265 Burlington Road

APPEAL REF: APP/T5720/W/20/3250440

Merton Design Review Panel

Verdict: RED

Typical floor Aspects

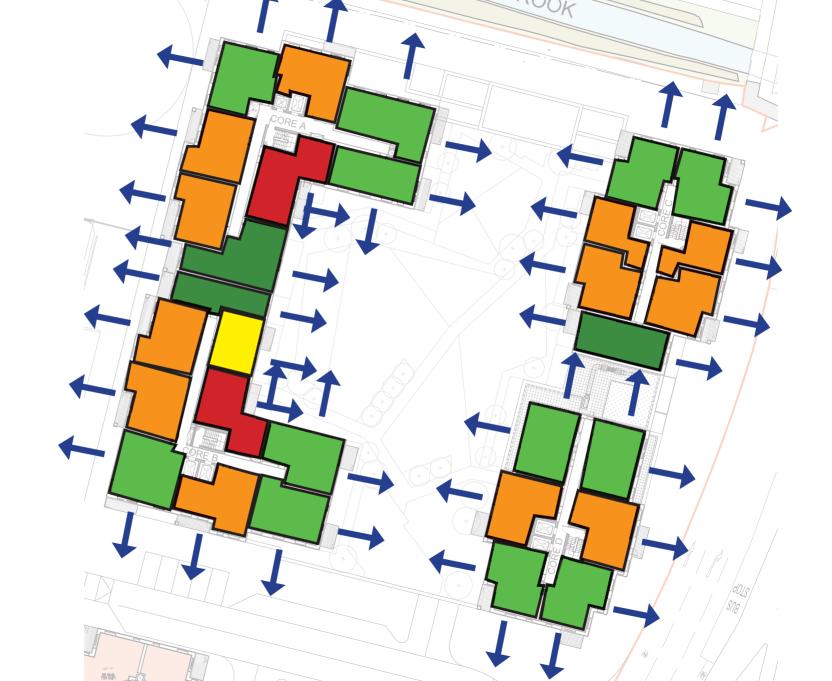
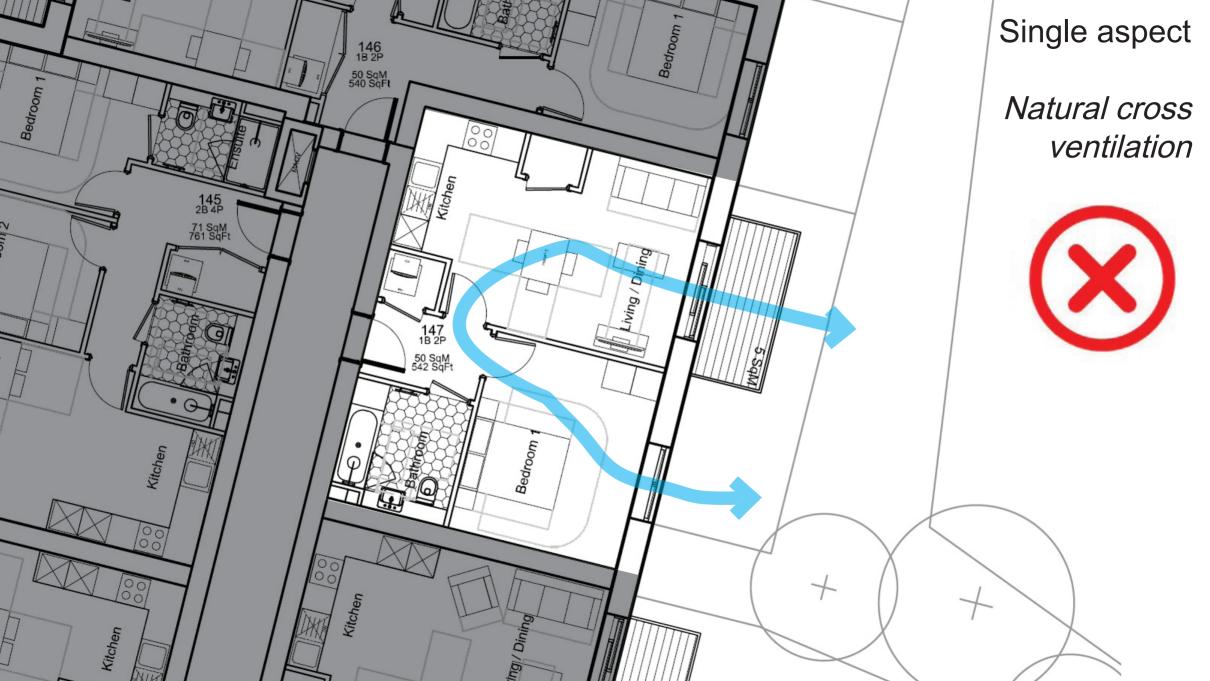
8.15.112 The Panel were also not convinced by the applicant's description of dual and single aspect dwellings as many units stated as dual aspect did not achieve the full benefits of dual aspect units. An effective 35% single aspect units was seen as an indicator that the development was too dense.

8.15.113 The London Plan residential design standards does not define what makes a dual aspect apartment, the angle required for dual aspect to adjacent walls or size of opening. In this way the residential units arranged with windows at 90 degrees that have two aspects in our development, should be considered dual aspect by definition.

7.8.7	All but one unit per floor, within the proposed development are dual aspect.
7.8.8	 On the typical lower floors there are 54 units per floor, which have the following breakdown: Through units (i.e. window at either end) – 6 per floor, 11%; Corner units (windows to two sides) – 29 per floor, 54%; Units with enhanced window return (windows to two sides) – 18 per floor, 33%; and Single aspect, east facing unit – 1 per floor, 2%.
7.8.9	There are no north facing single aspect units within the scheme
